Subject: Duke Energy Corporation
Catawba Nuclear Station, Unit 1
Docket Number 50-413
Steam Generator Outage Summary Report for End of Cycle
14 Refueling Outage
Reply to Request for Additional Information
(TAC Number MC1703)

REQUEST FOR ADDITIONAL INFORMATION

CATAWBA NUCLEAR STATION, UNIT 1

The Nuclear Regulatory Commission (NRC) staff has reviewed the licensee's submittal dated December 23, 2003, forwarding the End of Core (EOC) 14 Steam Generator Tube Inspection Report for Catawba Nuclear Station (Catawba), Unit 1. The NRC staff has identified the following information that is needed to enable the continuation of its review.

**Attachment 1
CFR 80 Steam Generators**

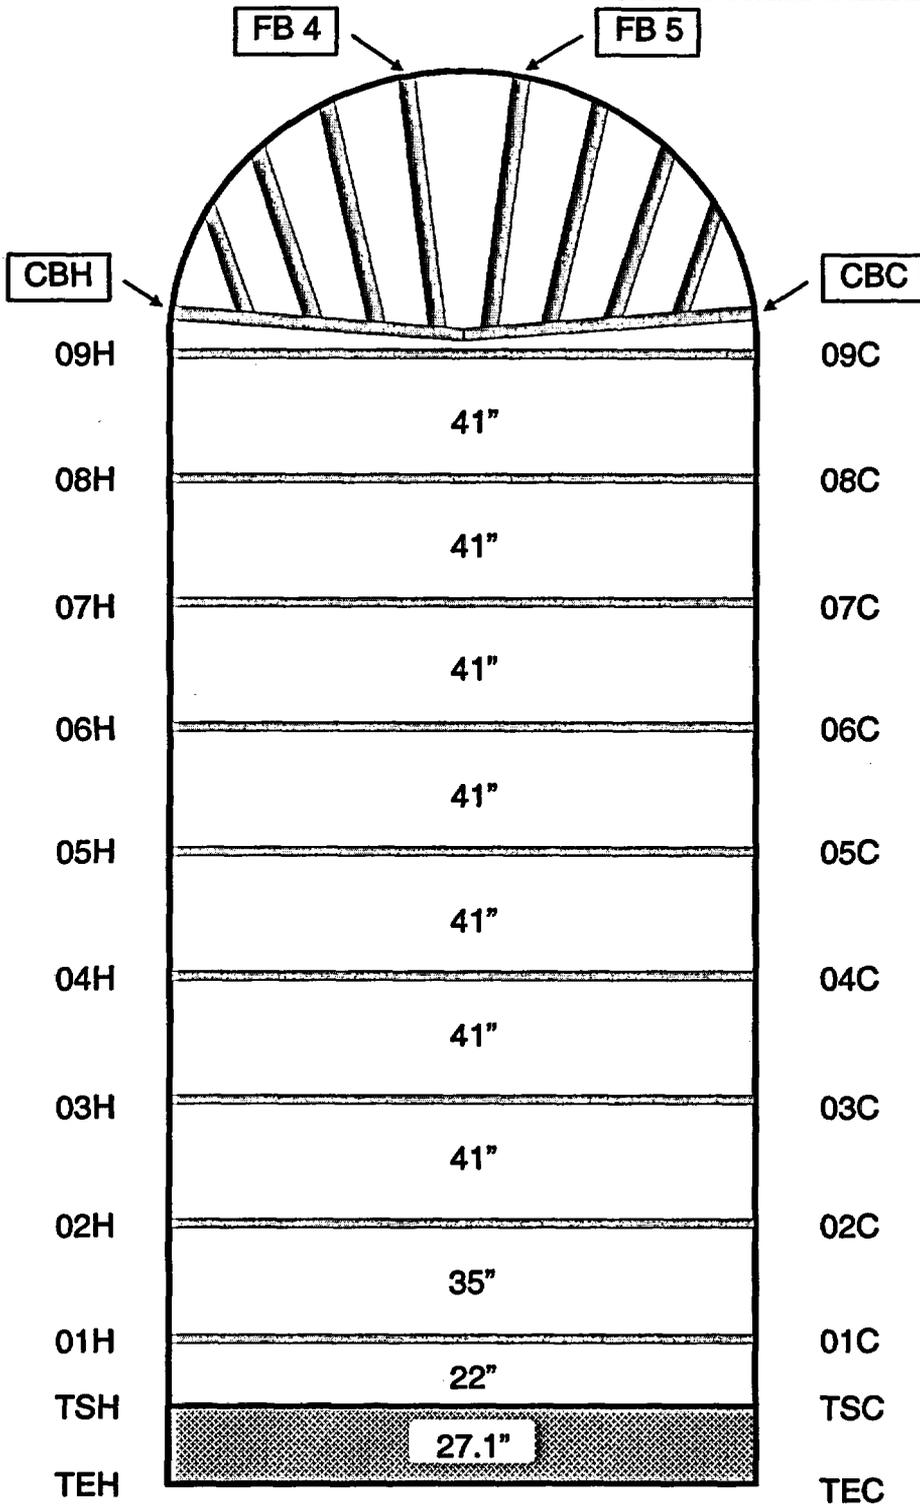
1. The steam generators at Catawba, Unit 1, were replaced in 1996 with Babcock and Wilcox International CFR 80 steam generators. In several locations in your reports, you reference tube support structures (e.g., fan bar 4) and tube locations (e.g., Row 14 Column 55). In order for the NRC staff to better understand the location of the indications, please provide (1) a sketch of the Unit 1 steam generators which depicts the tube support naming conventions and (2) a tubesheet map which depict the rows and columns of the tubes. In addition, please provide the following general design information: tube manufacturer, tube material, tube outside diameter, tube wall thickness, tube support (including fan bar/anti-vibration bar) material and configuration, tube support (including fan bar) thickness, tube pitch and orientation (e.g., 1.1-inch triangular pitch), expansion method, and any other noteworthy design characteristics from a steam generator tube integrity standpoint (e.g., full length stress relief of the row 1 through row 10 tubes). Furthermore, discuss whether measurements from a tube support are from the middle of the support or the edge of the support. For example, does fan bar 5 minus 0.9 inches specify an indication 0.9 inches from the bottom edge of the fan bar?

Attachment 1 is a sketch of the Unit 1 steam generators which depicts the tube support naming conventions and Attachment 2 is a tubesheet map which depicts the rows and columns of the tubes. Attachment 3 is the rotating coil characterization codes. Attachment 4 is the bobbin coil characterization codes.

Positive direction is physically upwards in the steam generator with the positive direction stopping at the apex of the U-bend. Measurements should be made using the nearest available landmark. All measurements should be referenced from the center of a landmark. Measurements may be made in a positive or negative direction using the nearest available landmark.
